Millcreek Township Planning Commission

Public Meeting Agenda

July 10, 2013 4:00 P.M.

Executive Summary									
Hearing Body:	Millcreek Township Planning Commission								
Meeting Date and Time:	Wednesday, July 10, 2013	04:00 PM	File No:	2	8	3	6	8	
Applicant Name:	Steve Davies & Rick Plewe	Request:	Conditional Use						
Description:	8-lot Single-Family Planned Unit Development Subdivision								
Location:	3548 South Honeycut Road (1850-1860 East)								
Zone:	R-1-10 Residential Single-Family	Any Zoning Conditions?	Yes <input type="checkbox"/>	No <input checked="" type="checkbox"/>					
Community Council Rec:	Approval with Conditions								
Staff Recommendation:	Approval with Conditions								
Planner:	Spencer G. Sanders

SITE PLAN

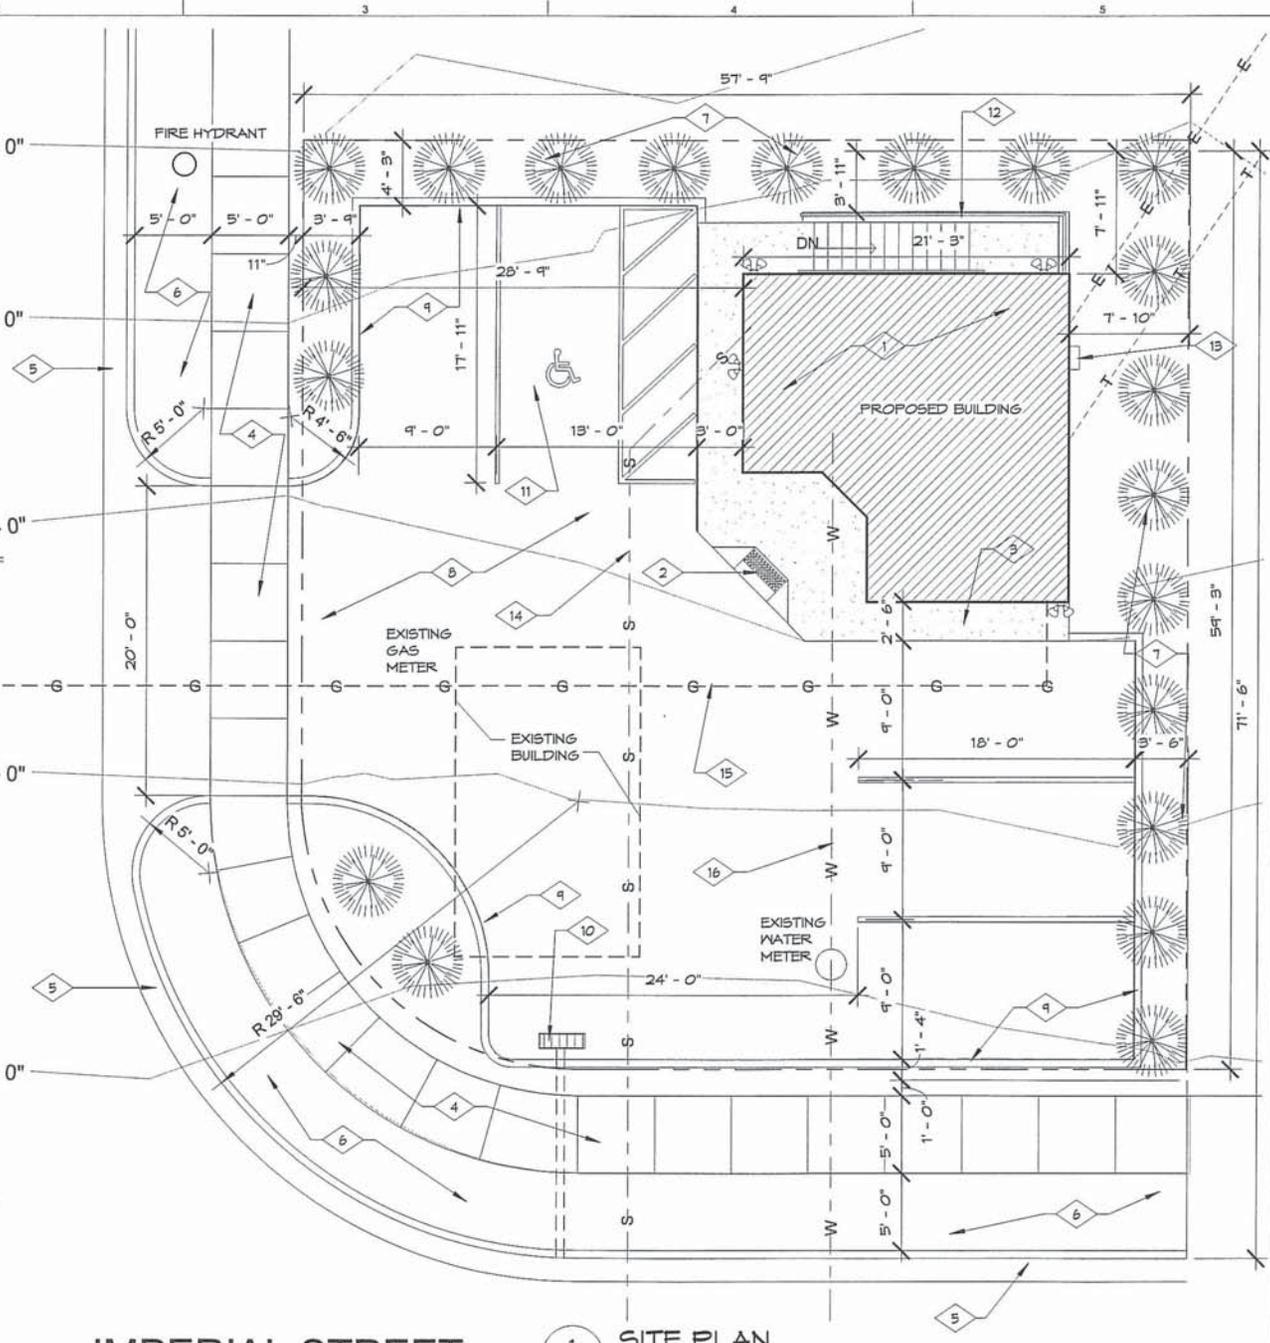
- 1) Staff finds that the site plan as proposed would create a burden to surrounding property owners and feels that the improvements being proposed to the site without the curb, gutter, and sidewalk will meet the intent of the board of adjustment approval for rebuilding and relocation of the existing non-conforming structure.

PRELIMINARY SITE PLAN
 CSP.01
 3 OF 8

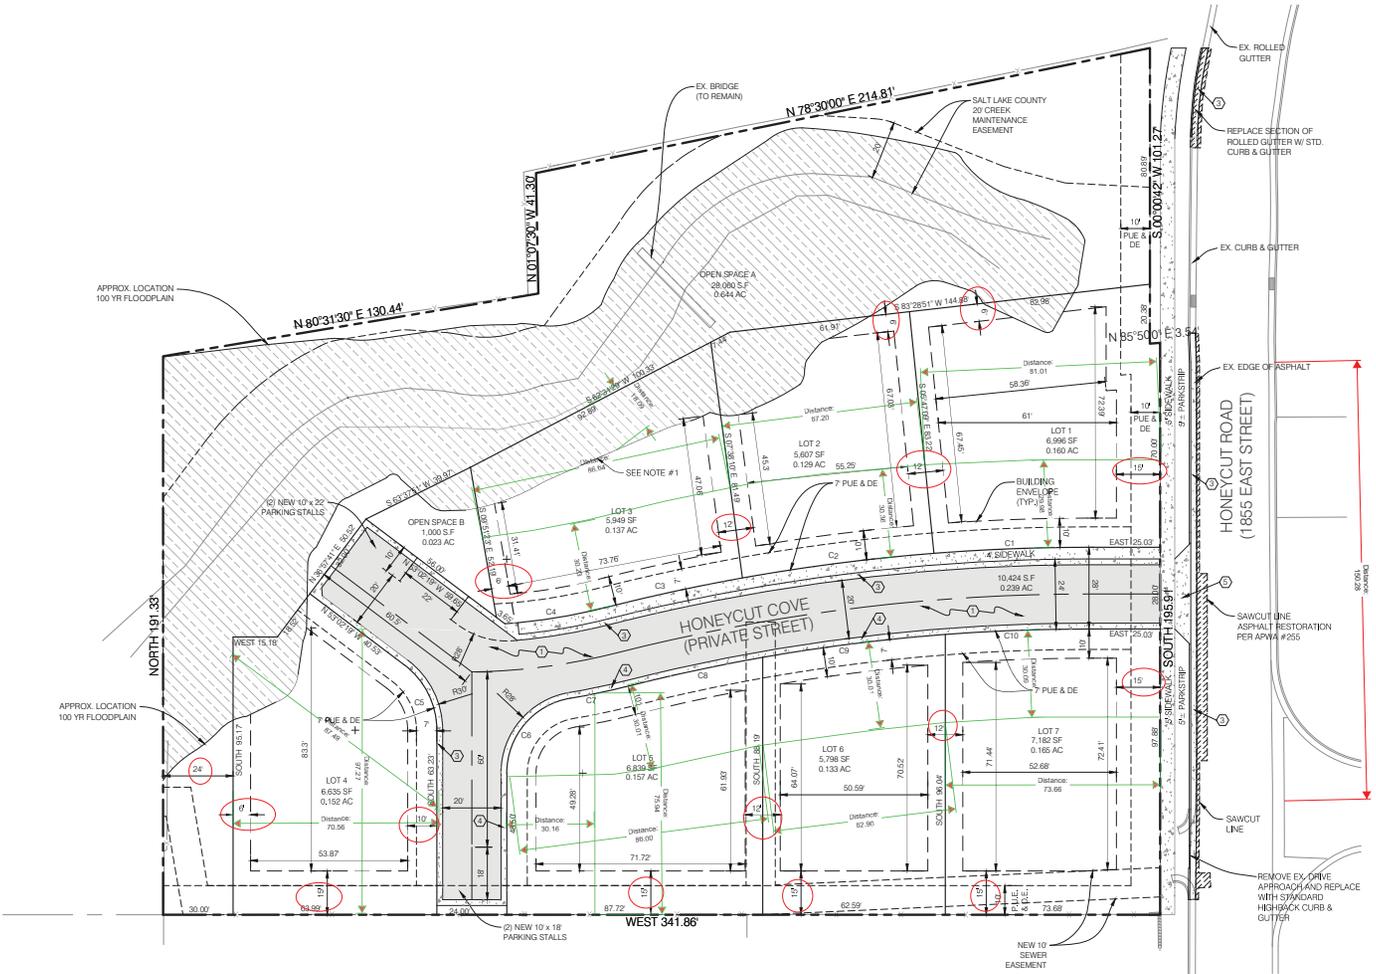
The applicant's current submittal shows the rear lot lines of lots 1-3 partially located within the FEMA floodplain boundary. In the case of lot three, almost the entire rear lot line is located approximately 18-20 feet into the floodplain. This places the rear lot line for Lot 3 very close to the edge of the ordinary high water level of the stream. (Please refer to the attached site plan.)

Staff has suggested to the applicants that these rear lot lines be relocated to the floodplain boundary. The slope from the floodplain boundary down to the creek is steep, particularly on Lot 3. It would be more appropriate to retain the floodplain area in the common open space rather than in individual lots. The applicants have agreed to make this change. Staff would recommend that that the rear setback for the homes on these lots be allowed to go to the new property line, with a small maintenance and construction easement, if needed, for home construction on these lots. Disturbance within this easement would be required to be restored.
